CERTIFICATE OF APPROPRIATENESS

Property: 1807 Kane Street, lot 12, block 442, Barker WR NSBB Subdivision. The property includes a historic 2,557 square foot two story residence and a one story detached garage situated on a 5,000 square foot (50' x 100') interior lot.

Proposal: Alteration – Install square columns, brick piers, and balustrades on the first floor porch to match those on the second floor. Relocate two existing windows on the front and east side elevations. Install 1 new window on the second floor of the west elevation

NORTH ELEVATION – FRONT FACING KANE STREET

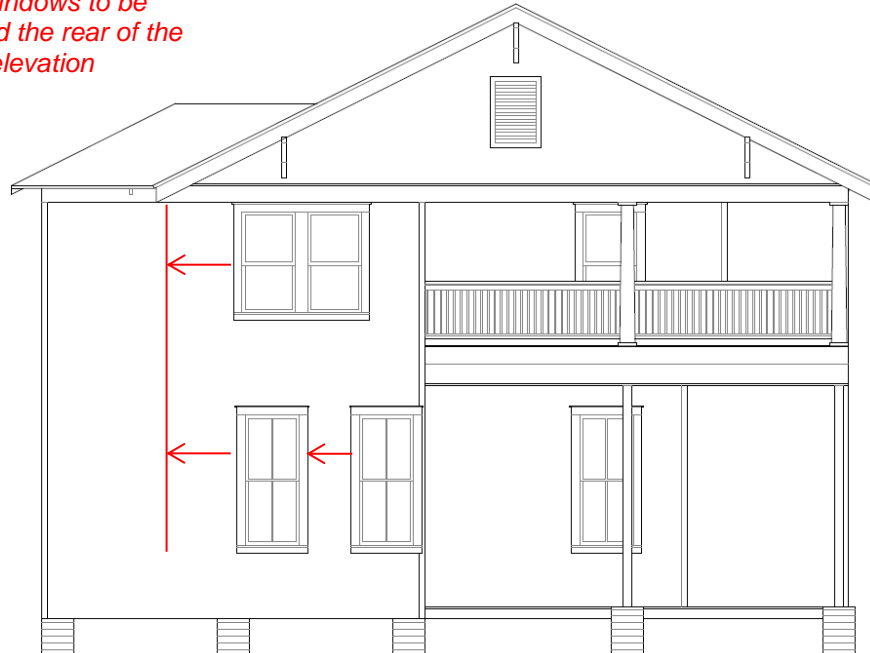
Existing windows to be moved to match the header height of the other first floor windows and doors

EAST SIDE ELEVATION

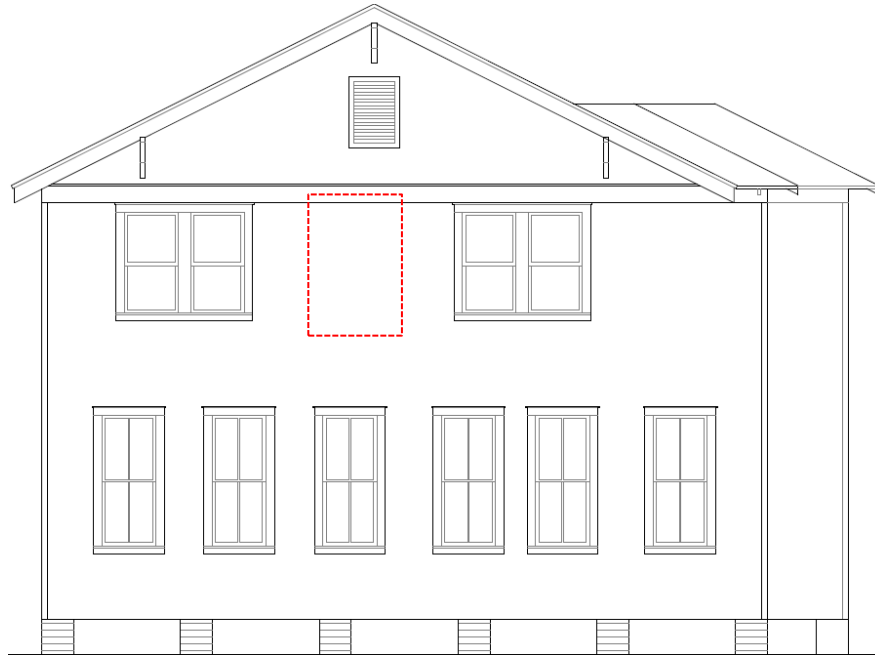
*Existing windows to be
moved toward the rear of the
east elevation*

WEST SIDE ELEVATION

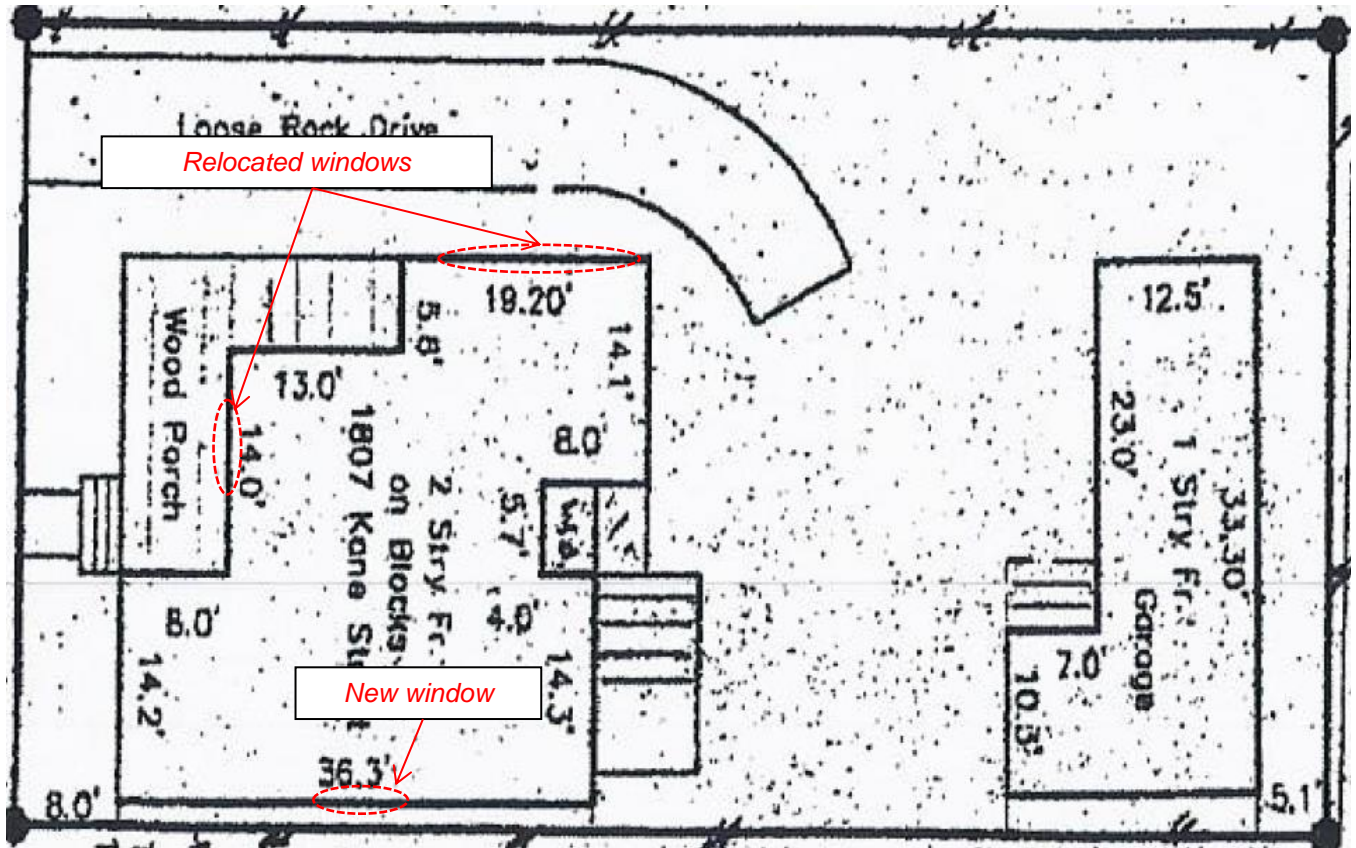
Side Elevation: Install a wood double hung 1 over 1 window at the center of the second floor of the west elevation.
